From: [Graham Petit](#)
To: [Vidaver, Regina](#)
Cc: [All Alders](#); [Neighborhood Meeting 2](#)
Subject: Re: Increase maximum allowed heights in height transition areas
Date: Tuesday, September 30, 2025 10:35:58 AM
Attachments: [image.png](#)

Subject: Increase maximum allowed heights in height transition areas

From: gordian@nym.hush.com
To: [Plan Commission Comments](#)
Cc: [All Alders](#)
Subject: Oppose Item 13; Legistar 89917
Date: Friday, October 3, 2025 2:51:07 PM

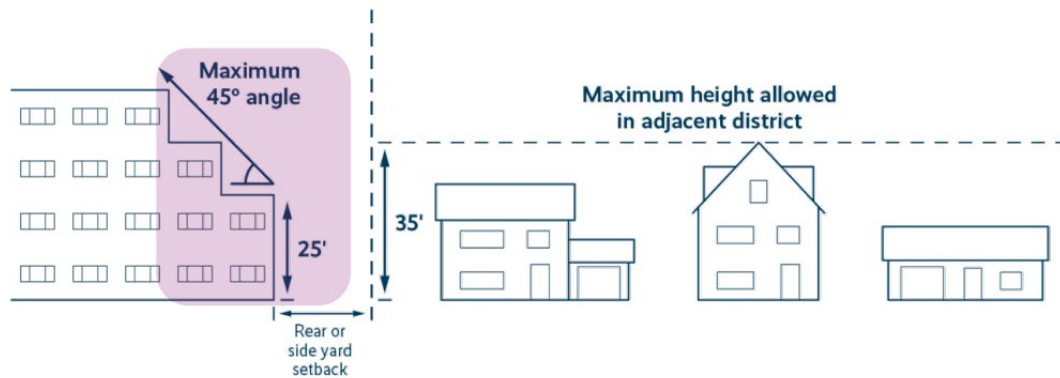
Thanks for responding. My concern with the proposal is that it bases requirements on the height of the adjacent district rather than building stories. Adding 10 feet (25ft to 35ft) is essentially adding an additional story to the building. The proposal documents include helpful illustrations that highlight this difference (see below).

*Subdivision (d) entitled "Rear or Side Yard Height Transition to Residential Districts" of Subsection (3) entitled "Dimensional Requirements" of Section 28.064 entitled "Neighborhood Mixed-Use District" of the Madison General Ordinances is amended as follows: "(d) Rear or Side Yard Height Transition to Residential Districts. **Where the NMX District abuts a residential district at the rear or side lot line, the maximum building height at the required setback shall not exceed the ceiling elevation of the highest occupiable story of the abutting structure as a permitted use.** From this point, building height may increase at a ratio of one foot of rise to one foot of horizontal distance away from the property line, (a 45° angle) up to the maximum allowed height. Transitions exceeding this height and/or ratio*

limitation require conditional use approval. (See Figure D12)

This wording change will ensure a gradual transition between residential and commercial buildings, covering a variety of circumstances, while still allowing for the option of a higher height limit where appropriate.
